**DART + WEST ELECTRIFIED RAILWAY ORDER 2022
Ref ABP-314232-22**

Module F: Landowner and Observer Submissions Zone F: Maynooth Station to Depot

Objection to the Proposed Siting of the EMU Depot and the associated Compulsory Purchase Order of Lands at Maws Farm, Maynooth West, Co. Kildare

Figure 4.5: Proposed Depot orientation and layout of site. (Source: Transport Insights, October 2020.)

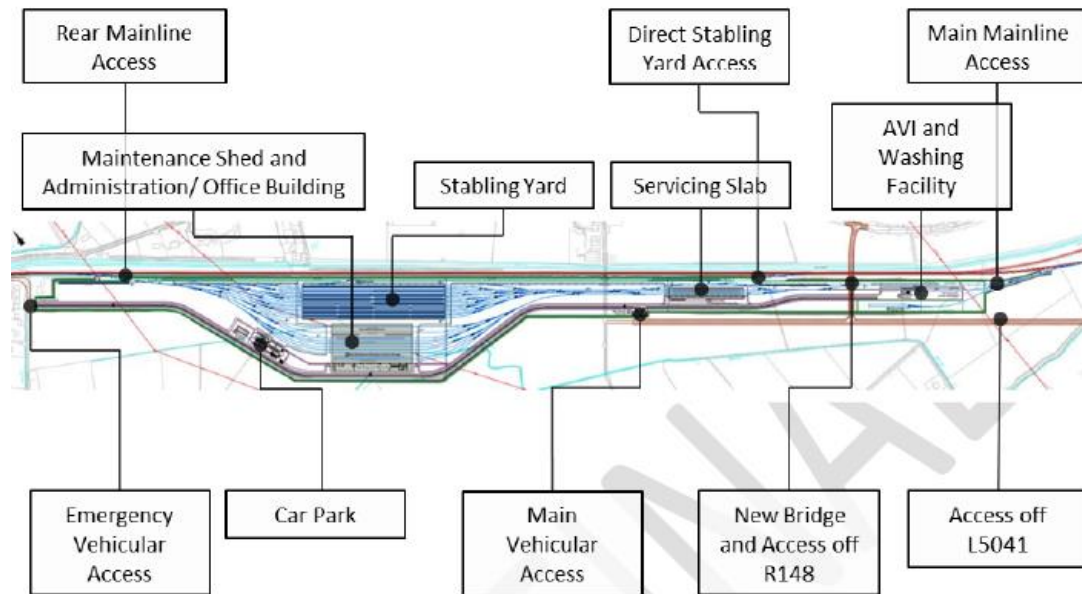
Many facilities, but dearth of cited floor areas?

Figure 6.2: Maynooth environs and proposed Depot site flood mapping.

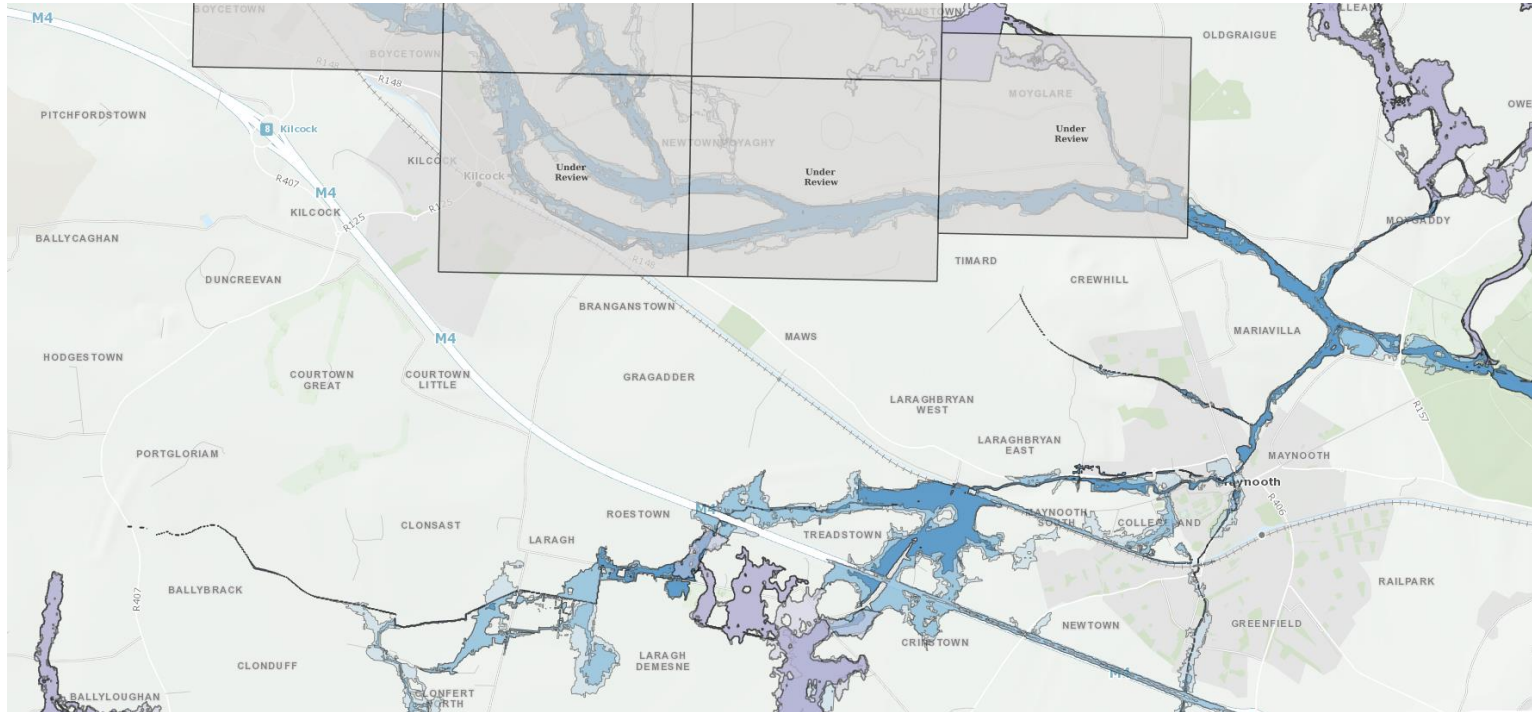
Maynooth flood analysis

Figure 4-251 Proposal for diversion of the existing water stream

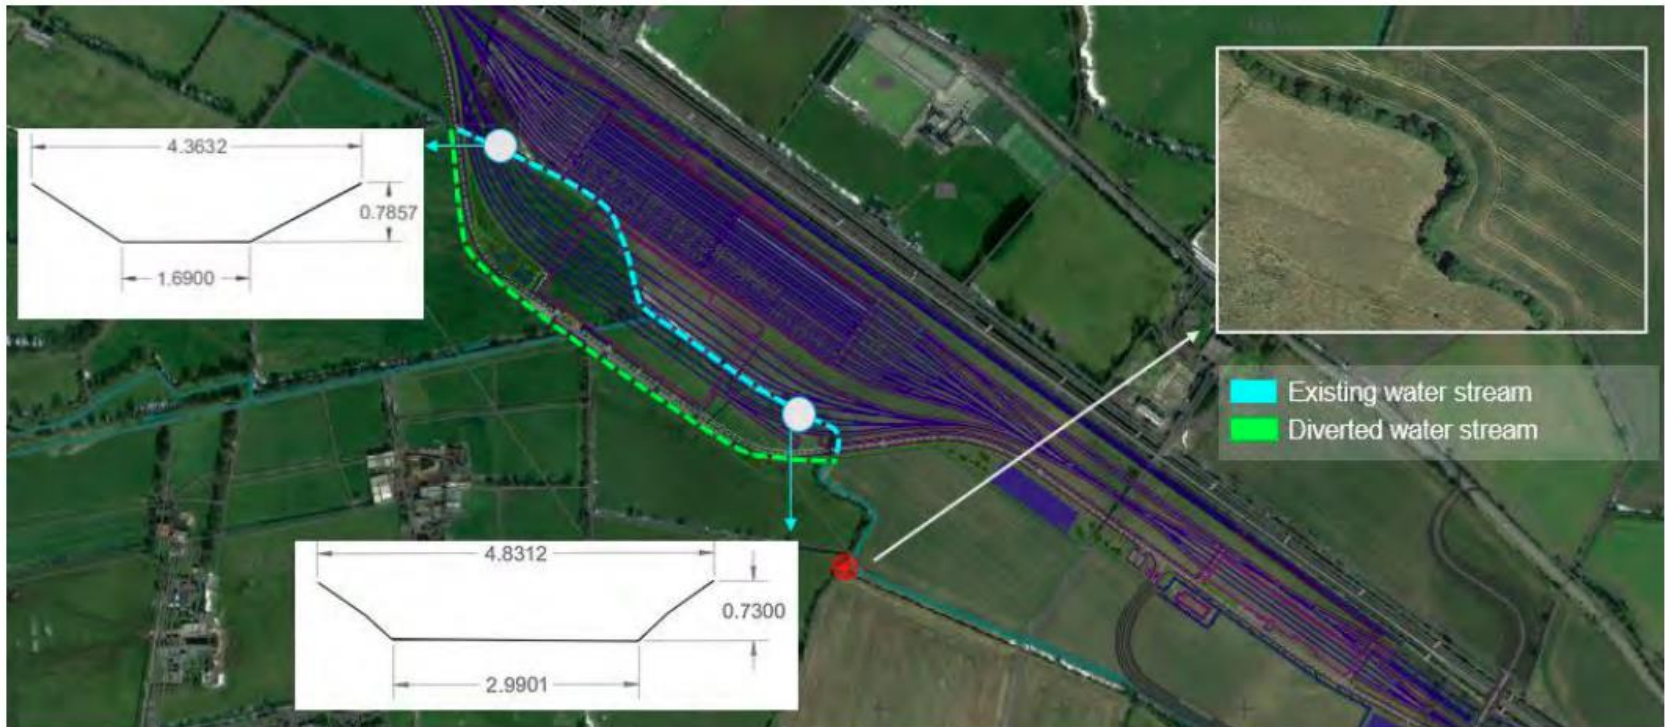
A significant environmental feat

Figure 2.7: Overview of the sub-catchments for Hydrological Assessment at Depot/Jackson's Bridge. Each letter A, B, C and D refer to different Catchment Areas of the Lyreen River. (Source: DART + West SFRA Document, page 24, annotated by Tom Phillips + Associates, October 2022.)

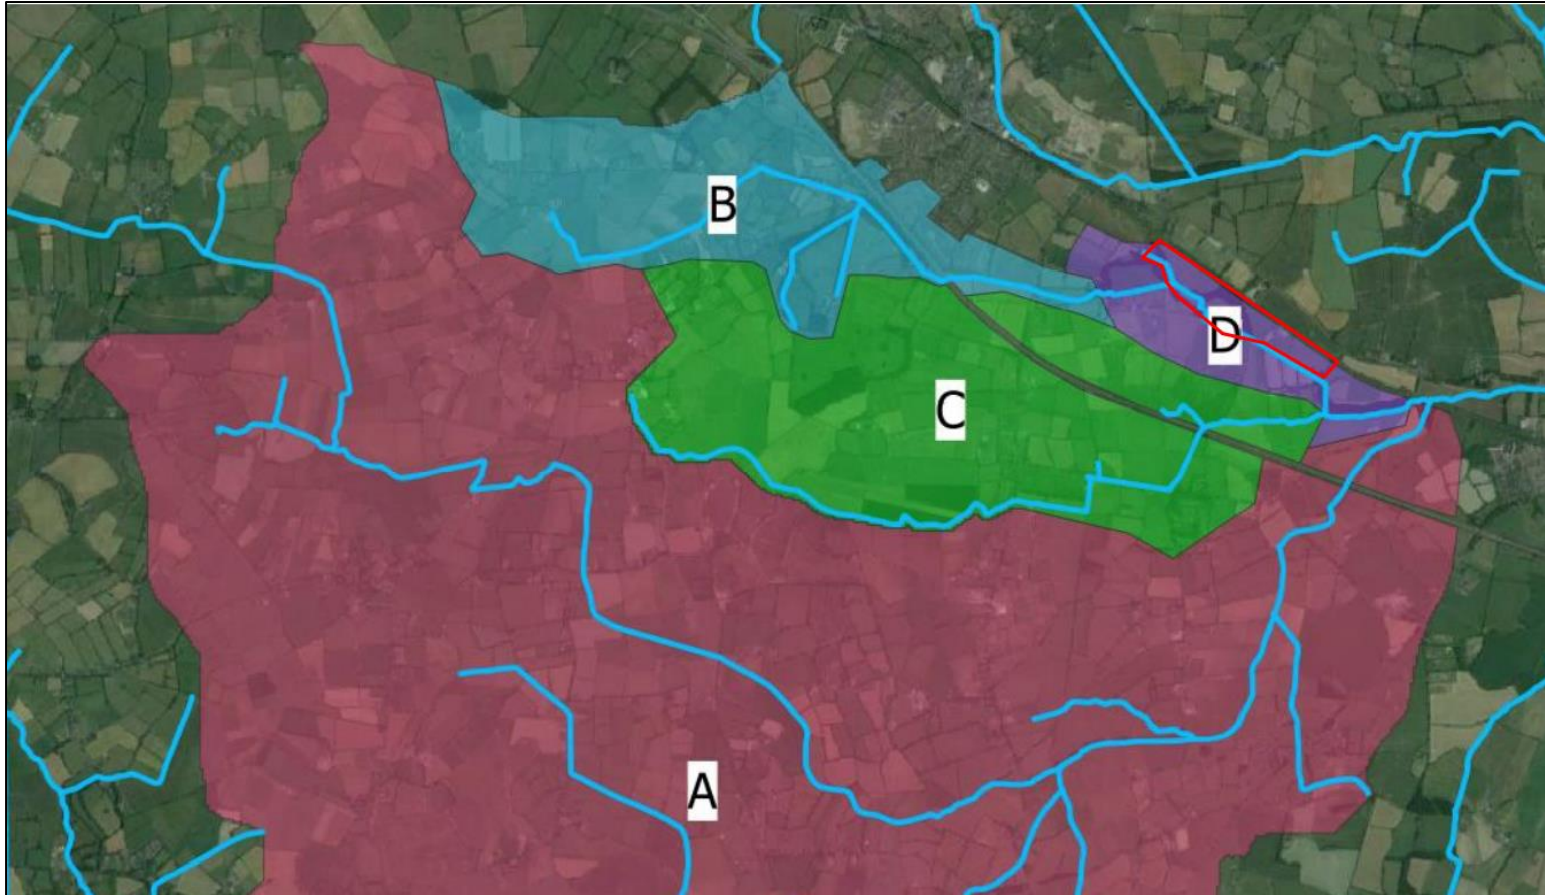
Catchments not taken into consideration.
Continuations.
C+B incorrectly drawn
A not fully drawn

Figure 4-258 Compensatory storage area adjacent to OBG23 (c.9ha)

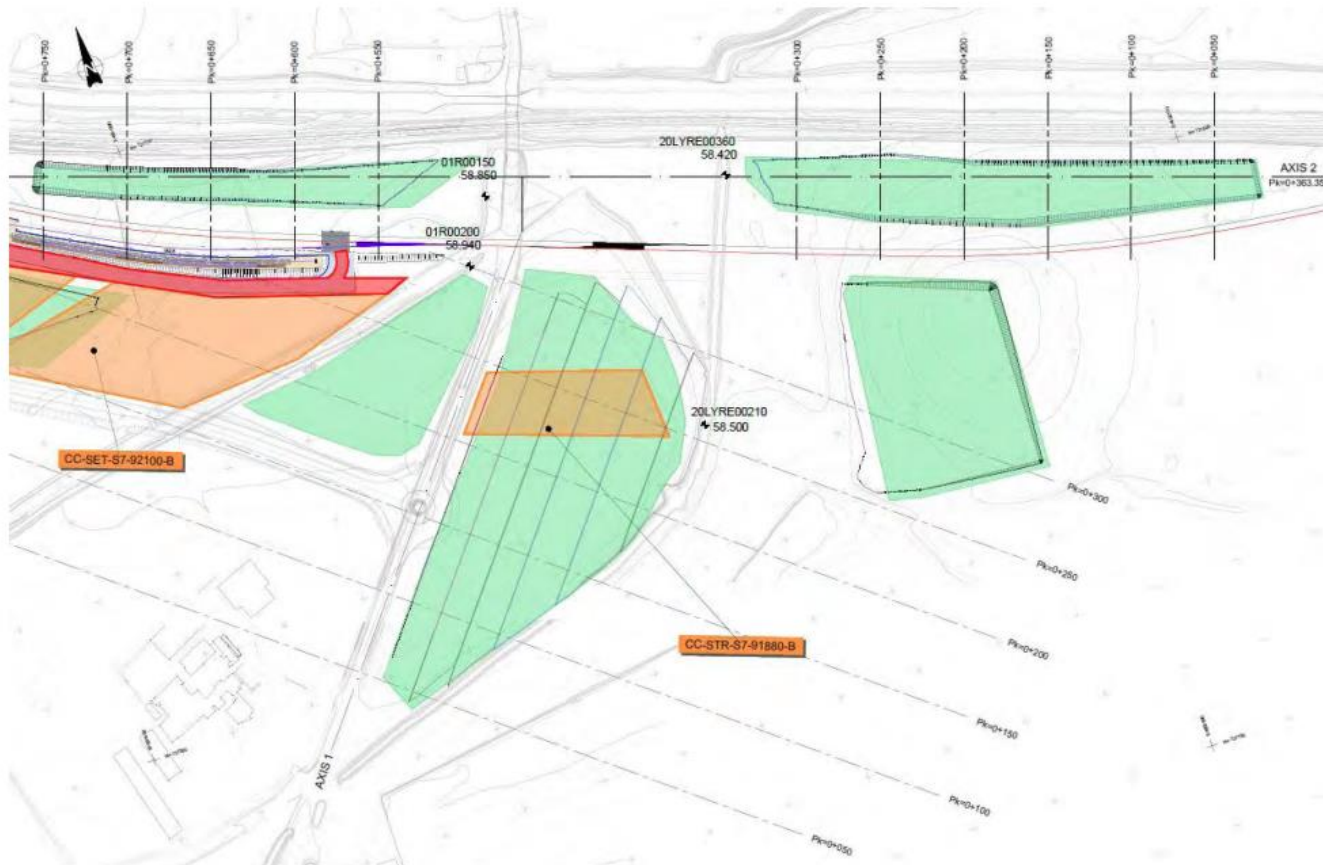
Can't read the drawings.
Writing too small

Figure 5.12: Map taken from DART + West SFRA Document showing the proposed *Compensatory Storage Areas* located south of Jackson's Bridge and directly above a vulnerable aquifer. (Source: DART + West SFRA Document, page 33, annotated by Tom Phillips + Associates, October 2022.)

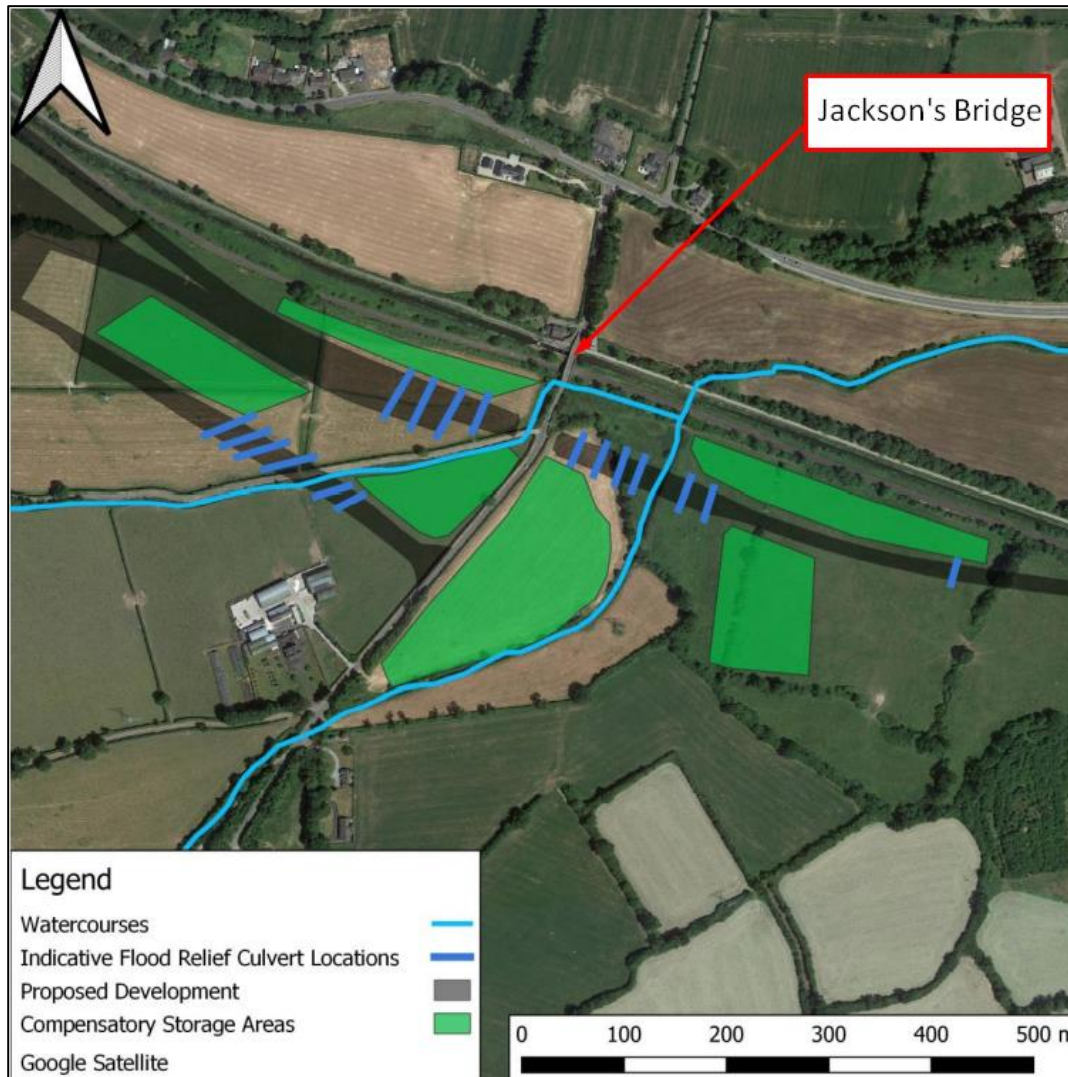
Blue lines are tunnels under Railways.
The river isn't opened to help release.
Analysis is flawed.

Figure 5.13: Overview of the proposed water attenuation storage areas located at the north-western portion of the Depot site. (Source: SART + West SFRA Document, page 34.)

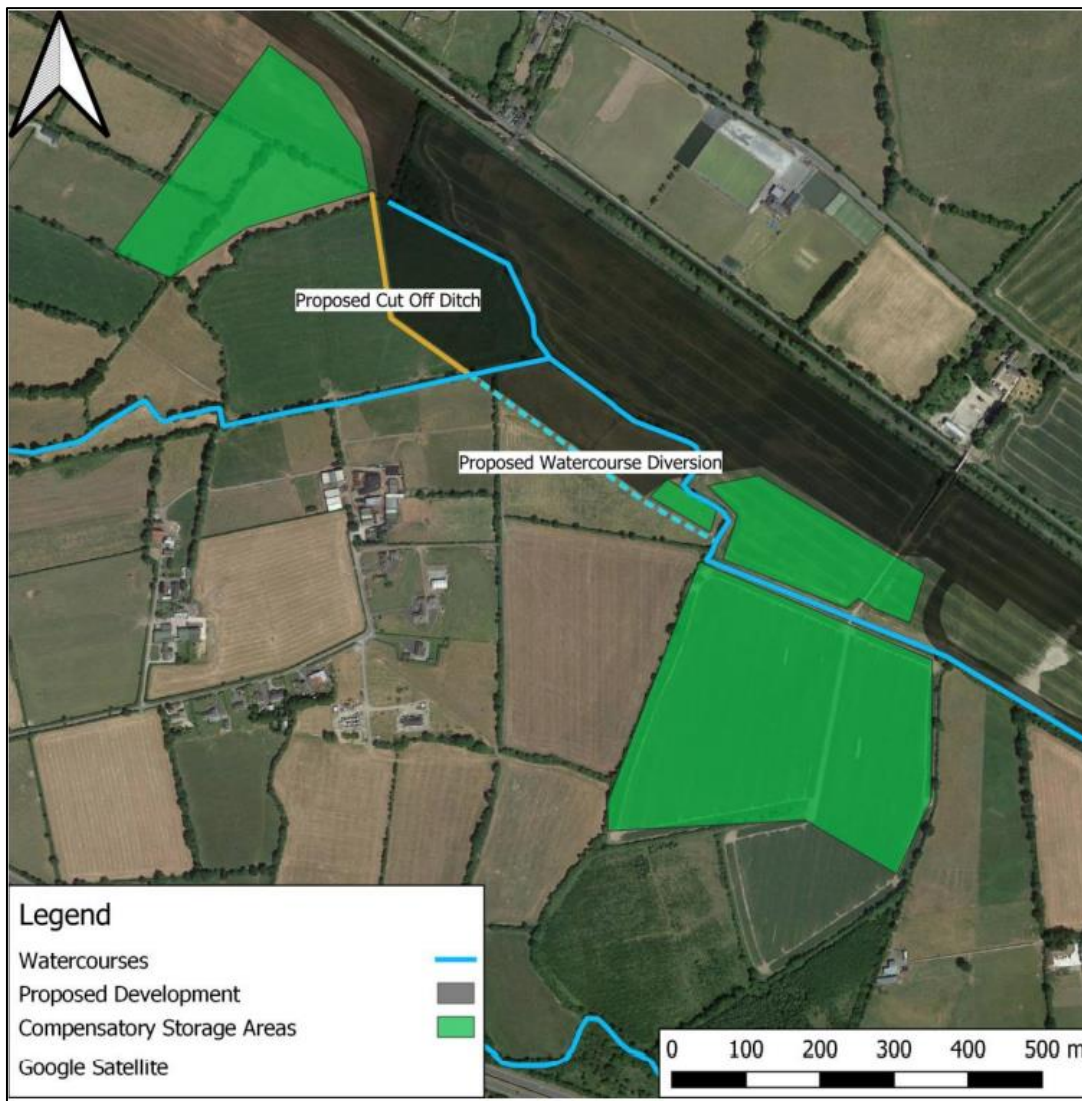
No analysis on 16 hectares.
Flow control mechanism.
Section excavated into ground – how will they control flooding.
